**UNITED
TECHNOLOGIES
CARRIER**

BULLETIN: CA-SB-19-D-88-109
DATE: 2/12/88
PAGE: 1 OF: 2

ESP REPLACEMENT PANELS

FIG. 1 REAR CIRCUIT BOARD OF ESP 11

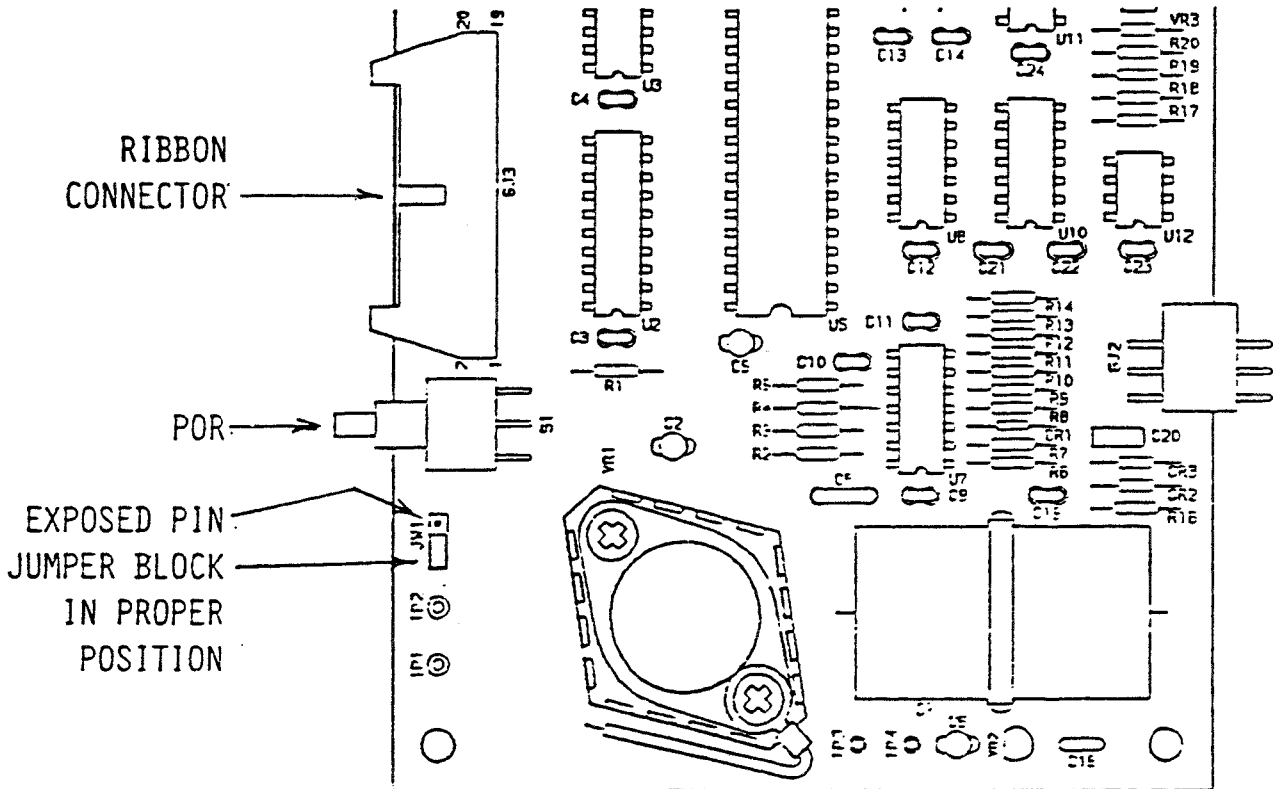
There is a new style ESP. The component layout is different and it does not have an option header receptacle.

Note: The ESP II rear printed circuit board has three small pins located in a row near the POR switch. For proper operation of the panel the center pin and the pin furthest from the POR (see Figure 1) are connected by a small blue slip-on jumper block. The vendor puts the jumper on the two pins closest to the POR for his quality test after production and then is supposed to move the jumper before shipping the panel. If the jumper is in the "factory test" position the display will be blank when the panel is powered up. If an ESP II is found with the jumper in the wrong position, just power down and move it over to the two pins away from the POR and then power up.
